Access Compliance Report

Public Rights-of-Way

Intersection ID: 11810	Main Street: ALLEN_ST	Cross Street: E_19TH_ST	Location: S
ADA ID: 56700001BA3E	Ramp Type: PerpDiag	Initial Pass/Fail: Fail	Overall Compliance: No
		Severity Score: 12.5

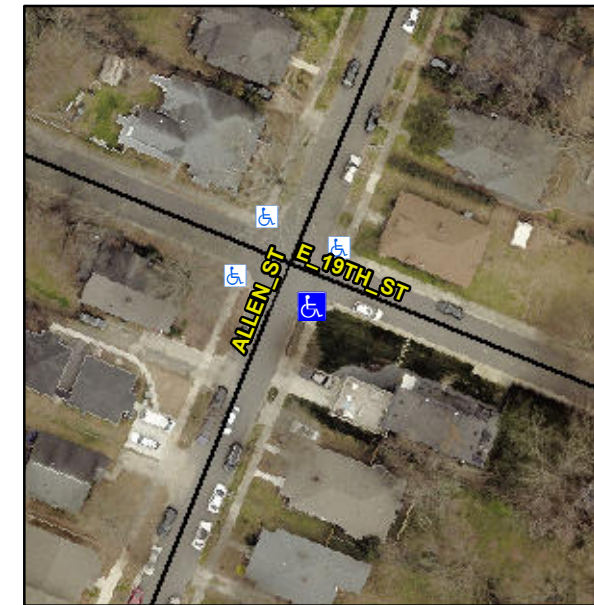
Not Found, R304.2.2

Compliance	Description	Data	Compliance	Description	Data
N/A	Ramp Length (in)	44.0	No	Ramp Slope (%)	8.4
Yes	Ramp Width (in)	63.0	Yes	Ramp XSlope (%)	0.3
N/A	Flare Type LT	N/A	N/A	Flare Type RT	N/A
N/A	Flare Slope LT (%)	N/A	N/A	Flare Slope RT (%)	N/A
N/A	Flare Traversable LT?	N/A	N/A	Flare Traversable RT?	N/A
N/A	Landing Length (in)	N/A	N/A	DWS Provided?	N/A
N/A	Landing Width (in)	N/A	N/A	DWS Contrast?	N/A
N/A	Landing Slope (%)	N/A	N/A	DWS Length (in)	N/A
N/A	Landing X Slope (%)	N/A	N/A	DWS Full Width?	N/A
N/A	Landing Curb? (Y/N)	N/A	N/A	DWS Offset (in)	N/A
N/A	Shared Landing?	N/A			
N/A	Gutter Ponding?	N/A	N/A	Gutter Slope (%)	N/A
N/A	Gutter Lip Ht (in)	N/A	N/A	Gutter X Slope (%)	N/A
N/A	Painted X Walk1?	No	N/A	Painted X Walk2?	No
	X Walk 1 Direction	To NE		X Walk 2 Direction	To NW
N/A	X Walk 1 Width (in)	N/A	N/A	X Walk 2 Width (in)	N/A
	X Walk 1 Slope (%)	2.3		X Walk 2 Slope (%)	4.8
	X Walk 1 X Slope (%)	1.1		X Walk 2 X Slope (%)	1.0

Remove & Replace Curb Ramp With Two New Directional Ramps or Equivalent.
